**TOWN OF NEWBURGH
PLANNING BOARD
TECHNICAL REVIEW COMMENTS**

PROJECT: UNIFIRST- AMENDED SITE PLAN
PROJECT NO.: 18-01
PROJECT LOCATION: SECTION 34, BLOCK 2, LOT 38.32
REVIEW DATE: 24 JULY 2019
MEETING DATE: 1 AUGUST 2019
PROJECT REPRESENTATIVE: PITINGARO & DOETSCH CONSULTING ENGINEERS, PC

SITE PLAN

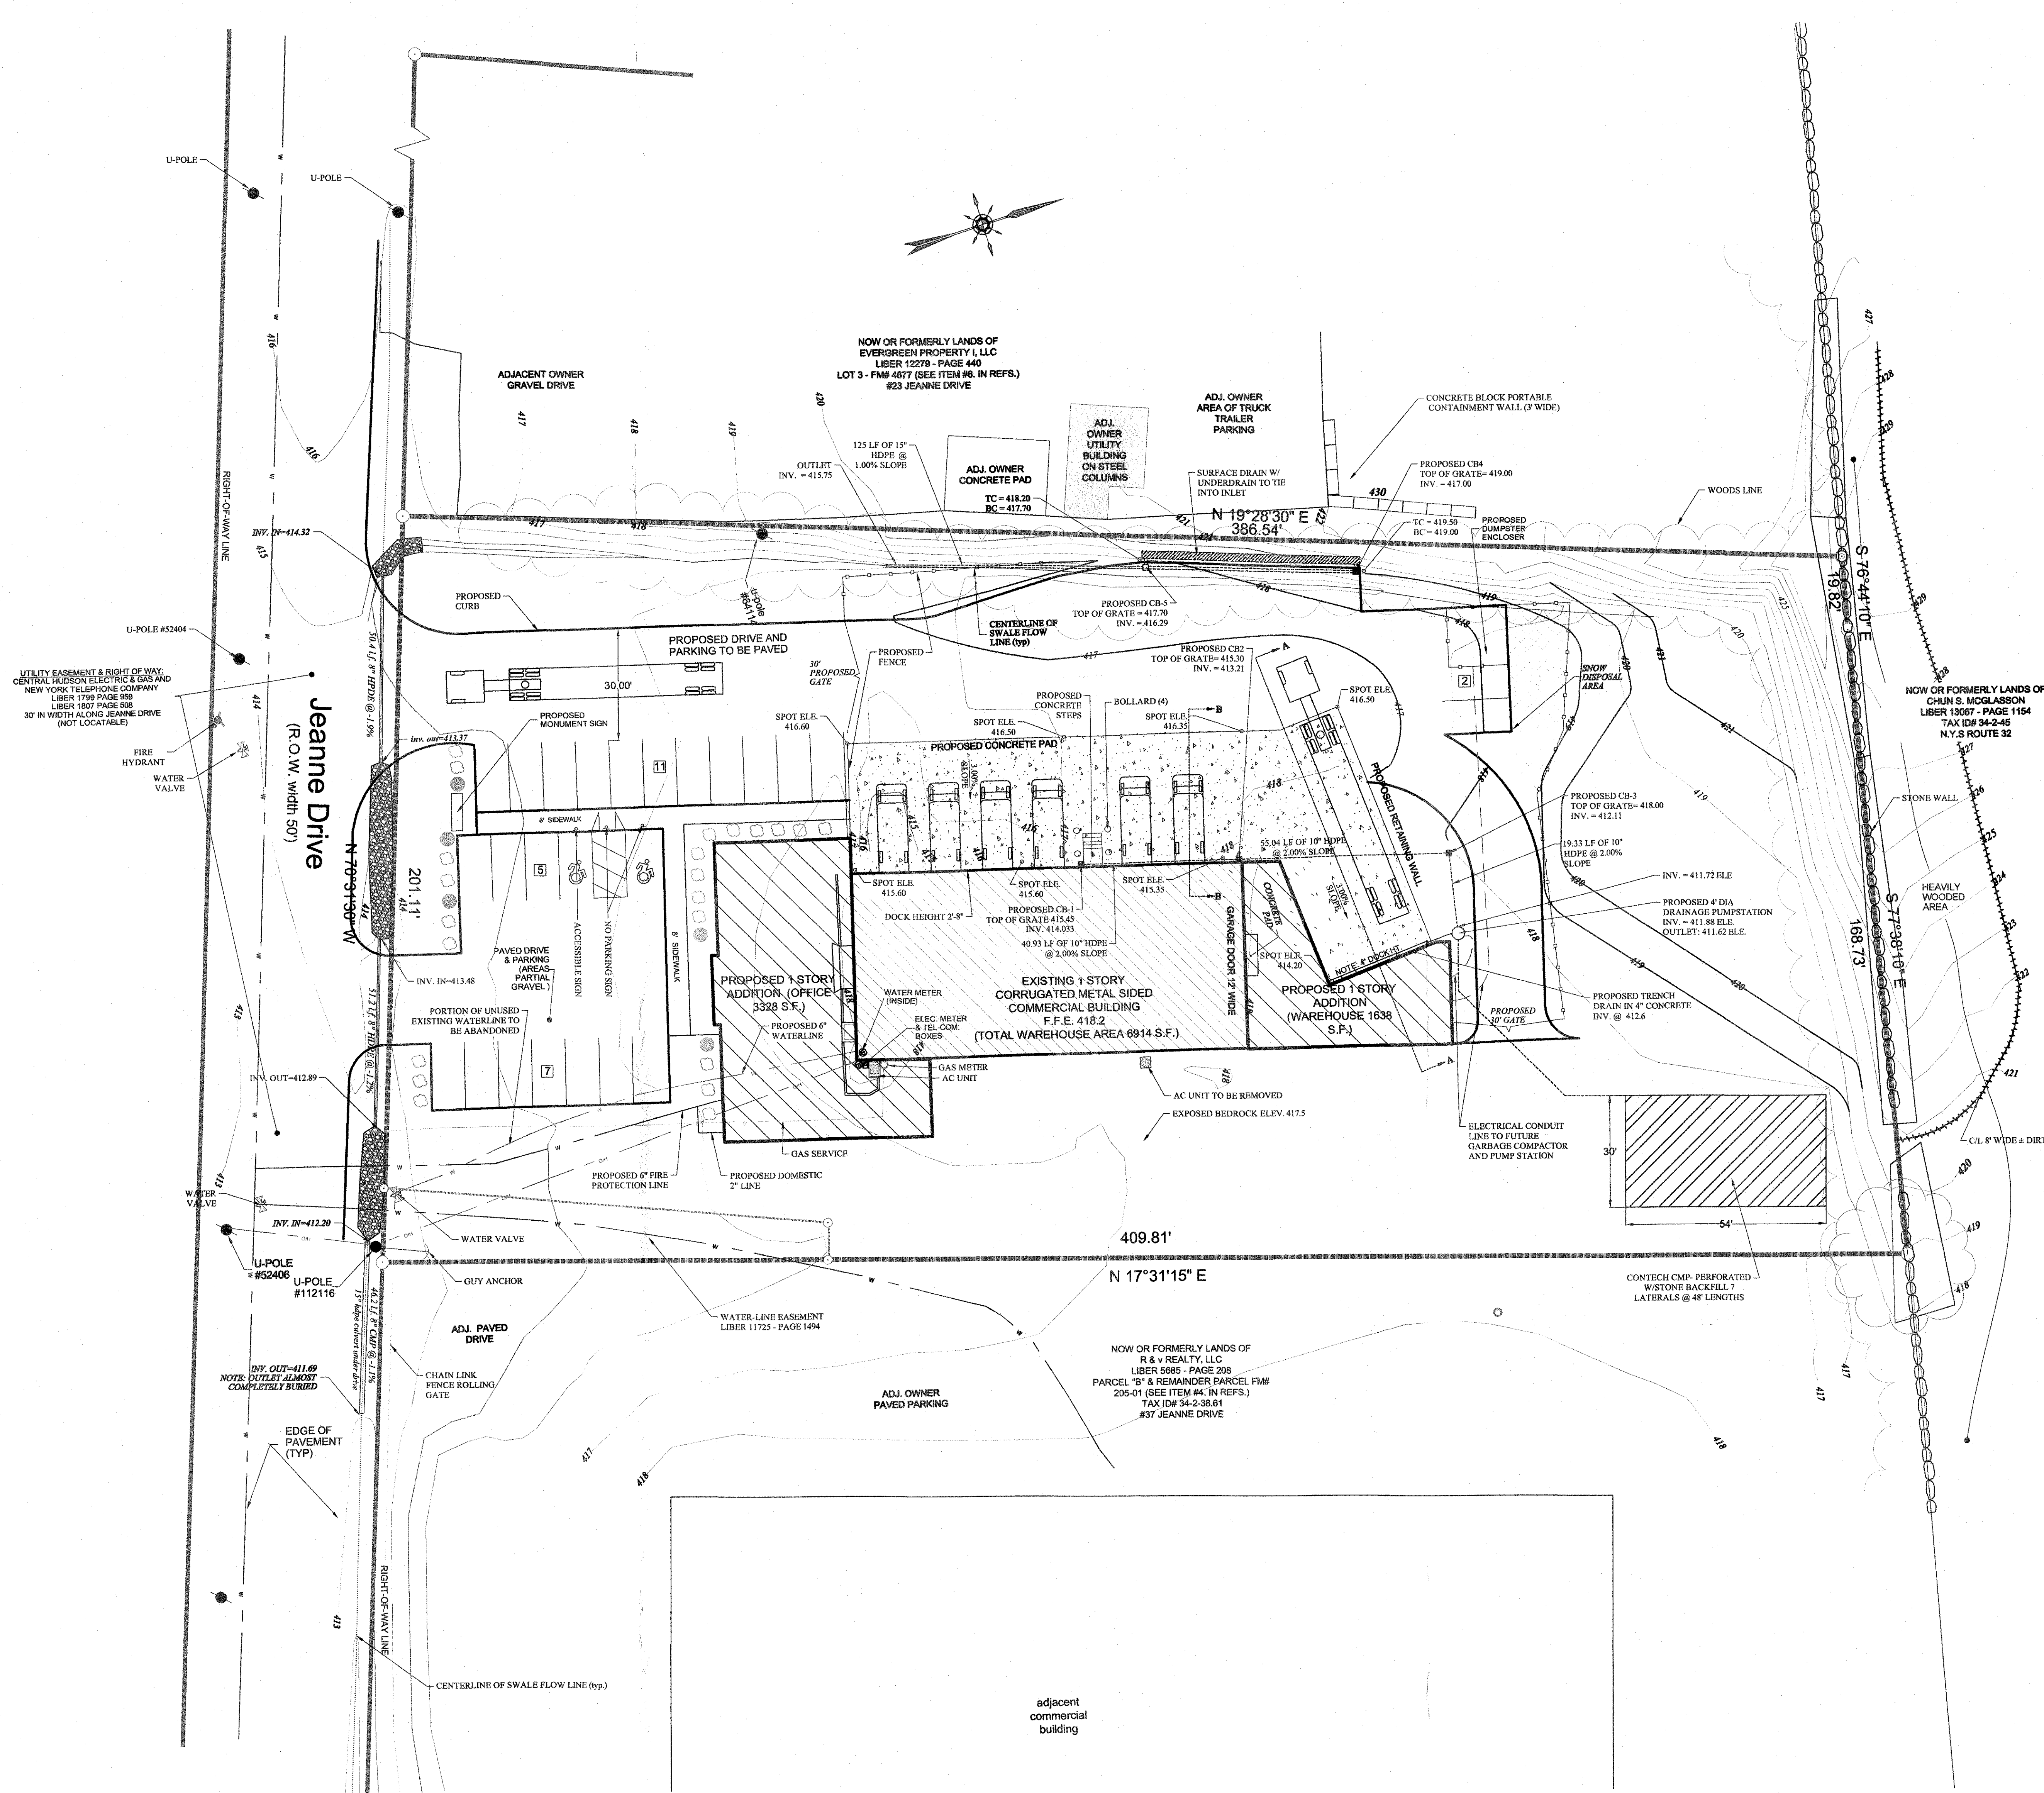
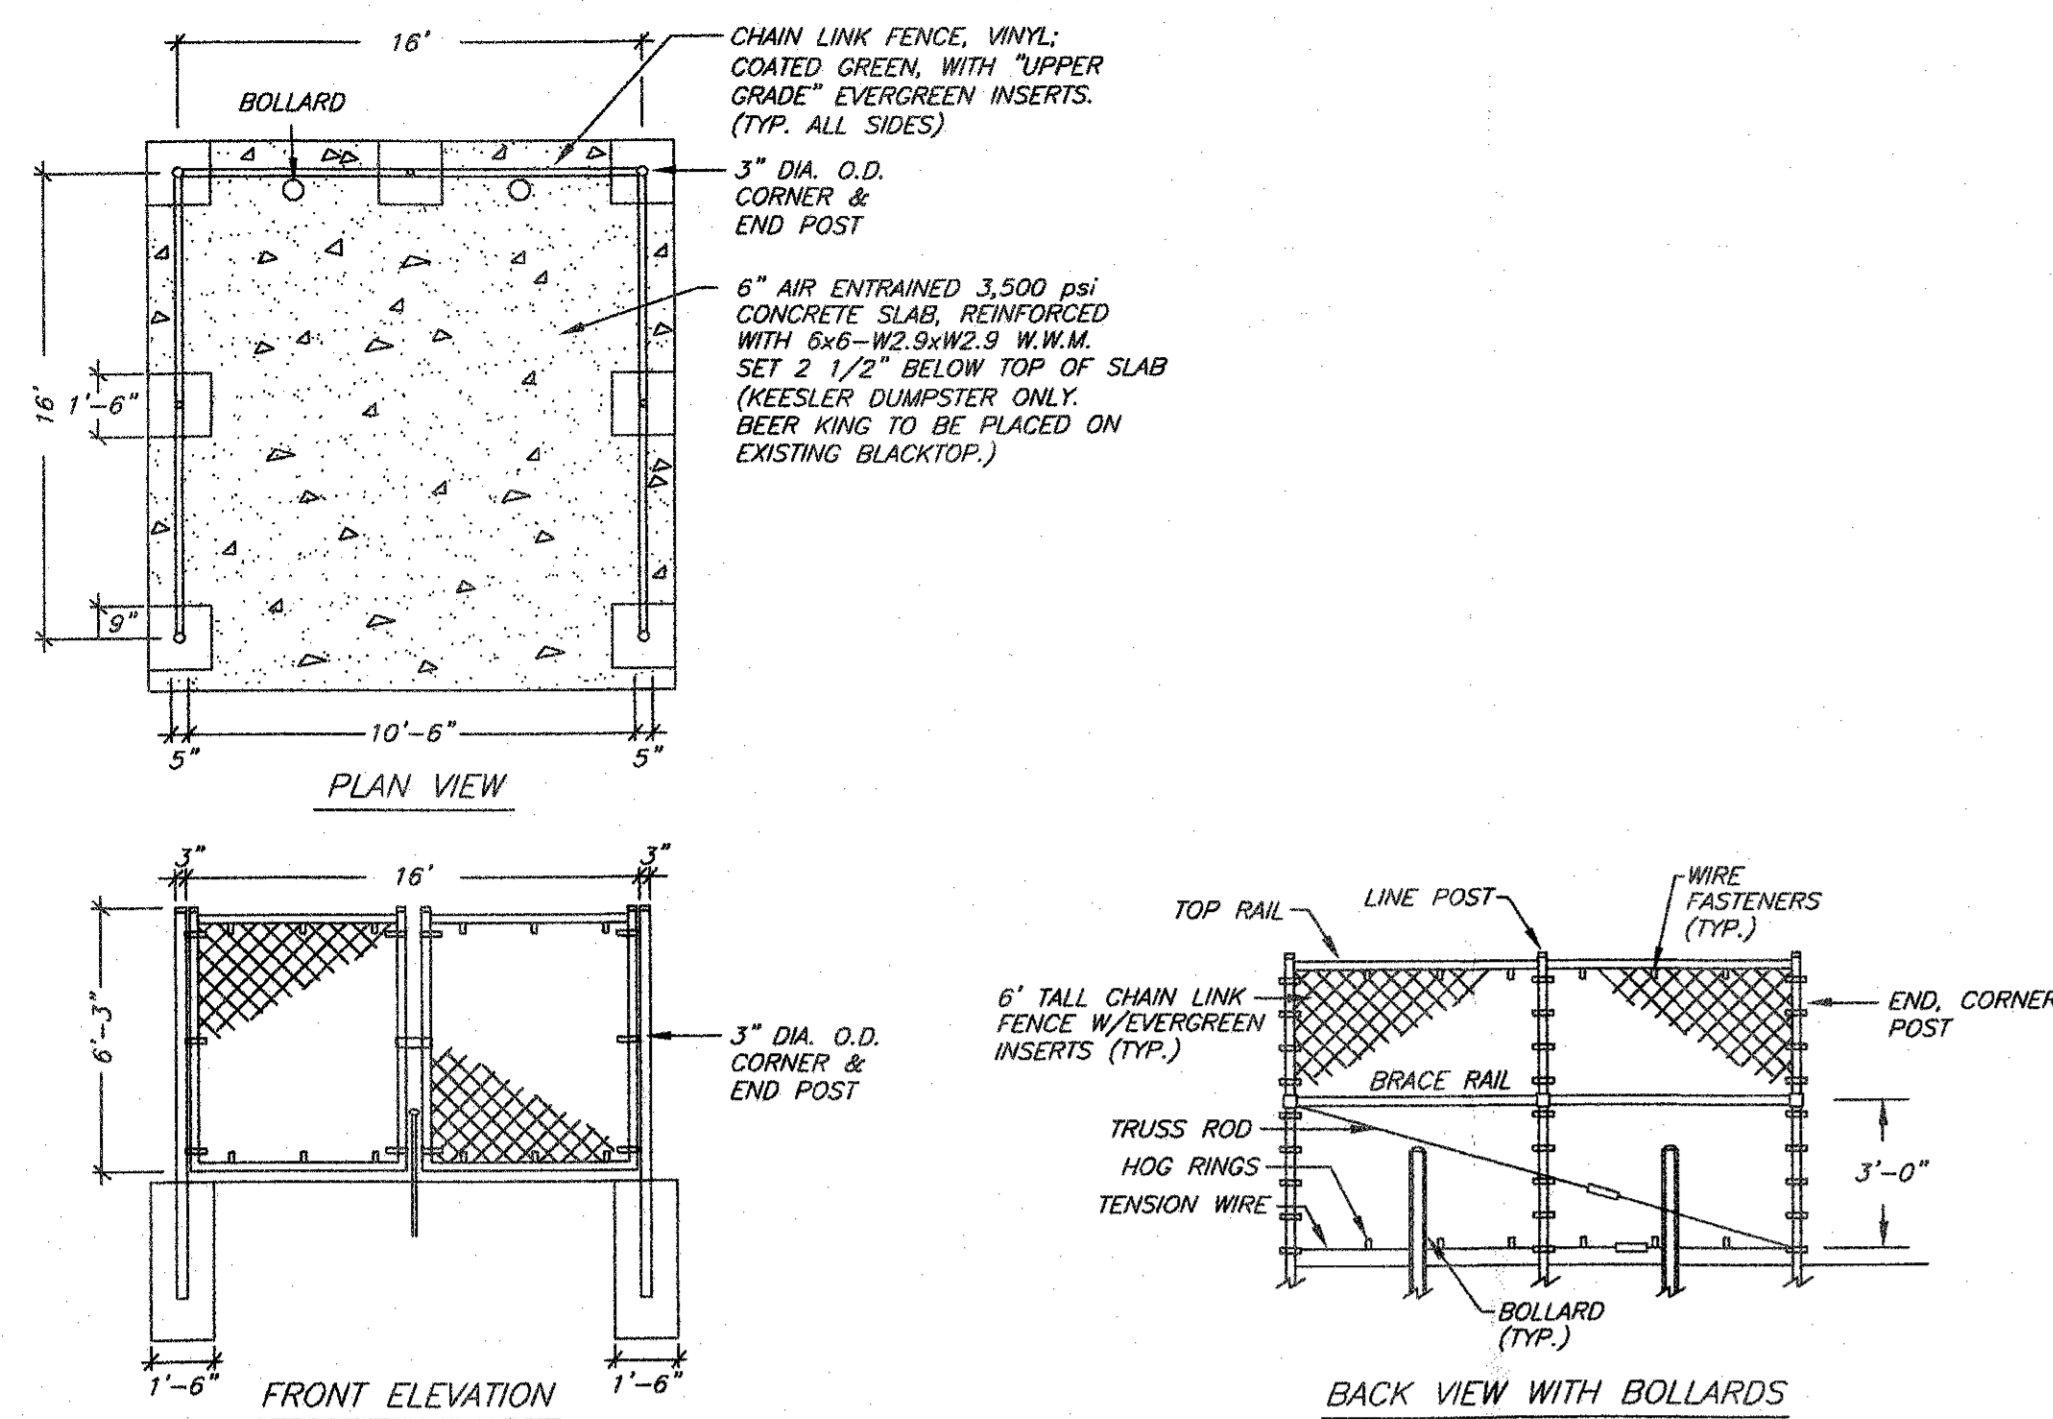
4. The number of employees in the warehouse should be further clarified. Numerous vehicles are depicted at loaded docks in excess of the 3 employees identified.

5. The fence does not appear to be contiguous along the western portion of the warehouse parking.
6. The Applicant's representative is requested to address fire sprinkler requirements in the building consistent with Town of Newburgh code. Valving for the water service should be such that when fire protection water is terminated potable water to the building is terminated. Standard Town of Newburgh water system connection notes and details must be added to the plans.

7. Grading for the loading dock should be identified, as a 417 contour exists in the vicinity of the truck while the loading dock is significantly lower. Additional spot elevations should be provided.
8. Retaining wall details should be added to the plans and depicted on the site plan where appropriate.
9. A report for the stormwater management pumping and treatment system should be provided detailing design of the pump station and soil testing depicting permeability of the soils in the vicinity of the underground thing.
10. The stormwater report should address the site as a stormwater hotspot for discharge from the trucking loading dock area.

EFFLUENT PUMP STATION
NOT TO SCALE

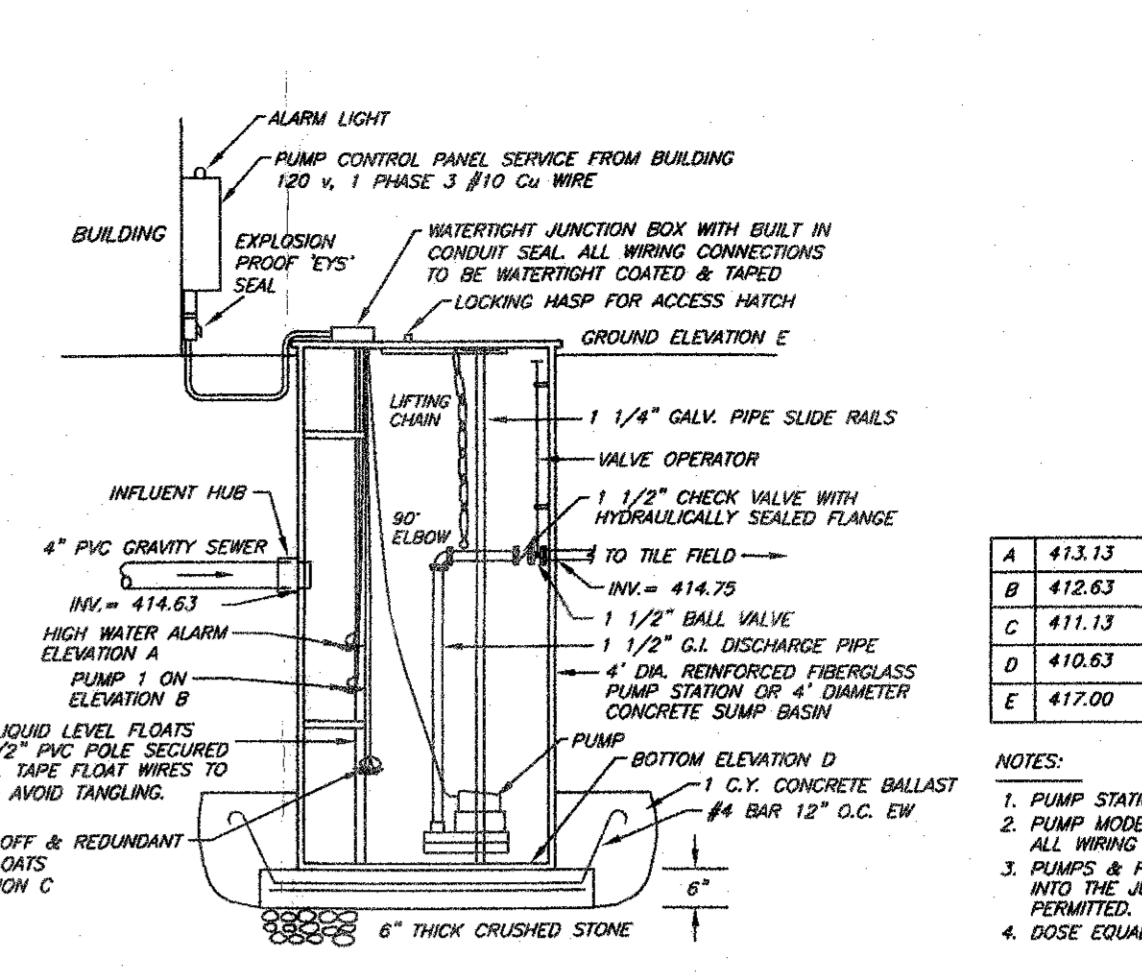
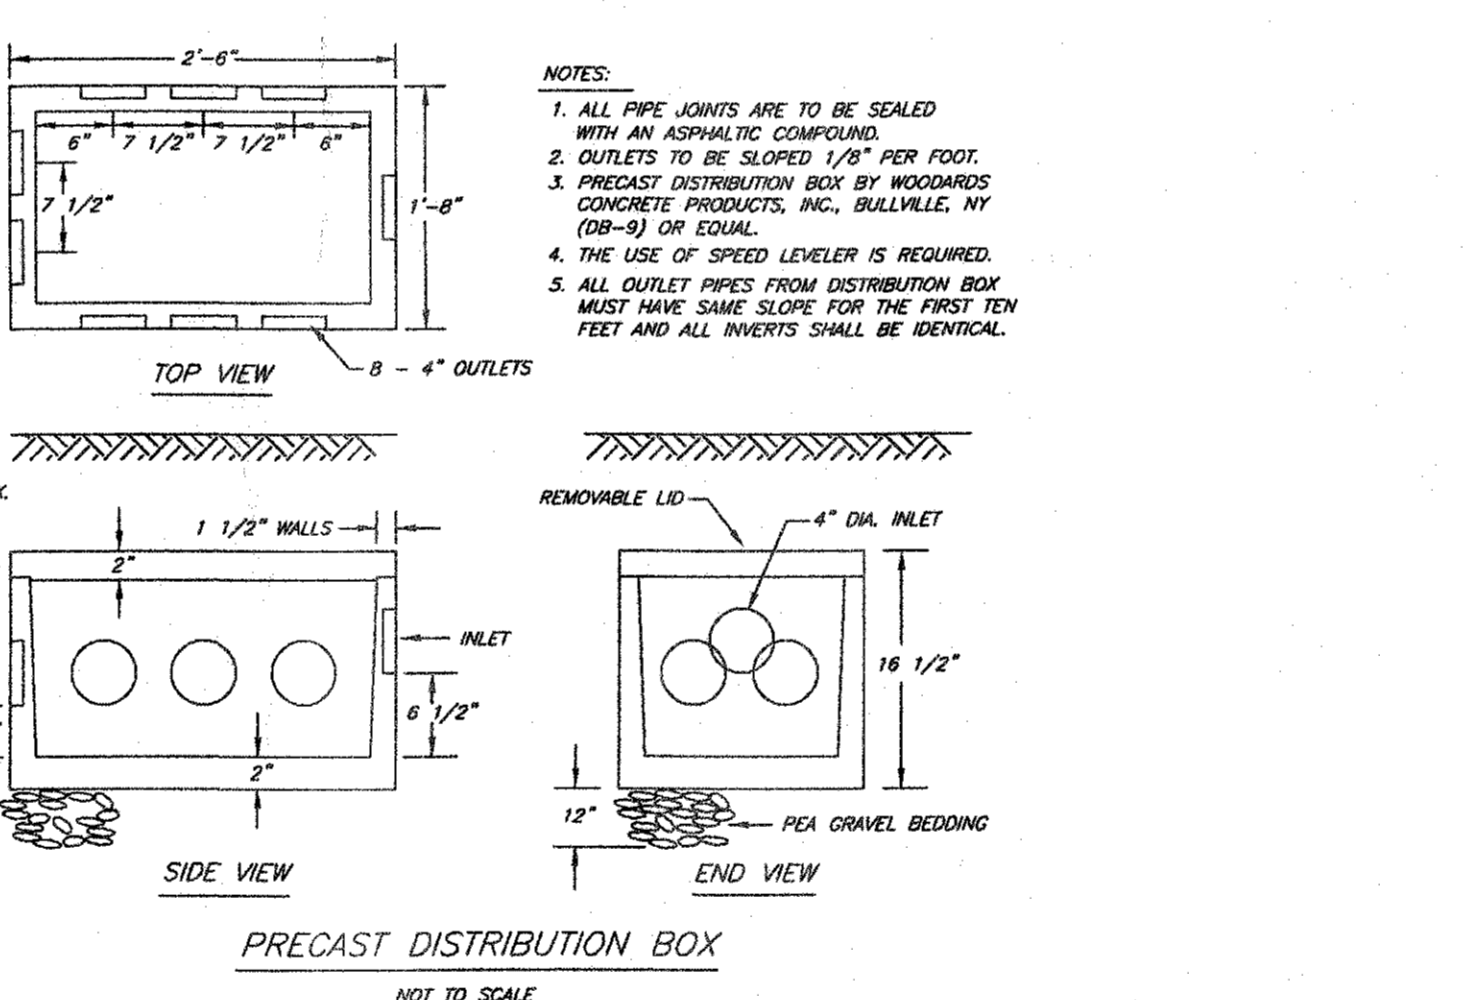
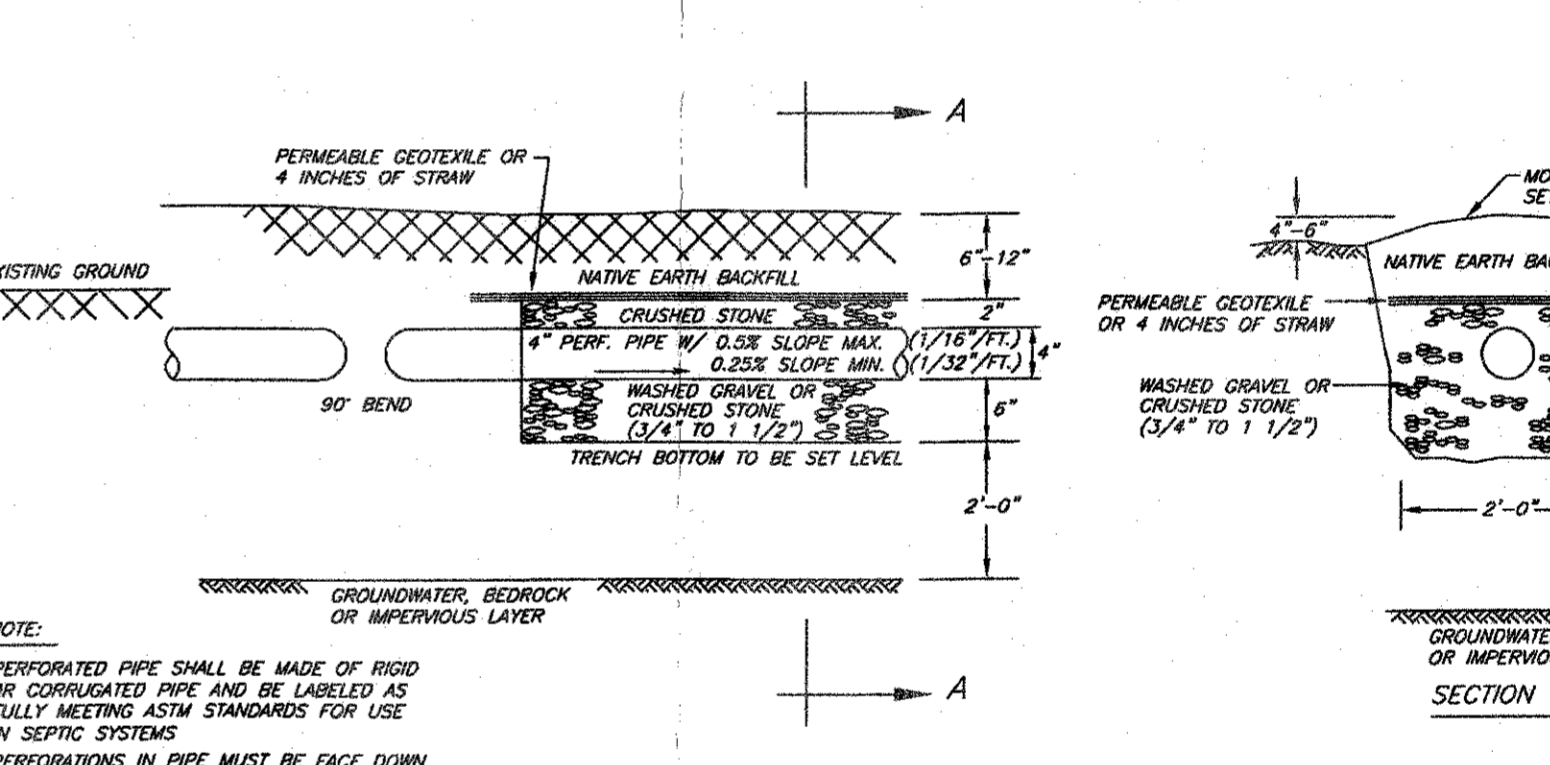
3. The Applicant's representative has designed a conventional Subsurface Sanitary Sewer Disposal System consisting of a shallow absorption trench system consistent with Health Department regulations. Septic details for the design must be added to the plans including proposed pump station septic tank, piping distribution and laterals. Design flow and lateral length vary on plan sheets and should be coordinated.
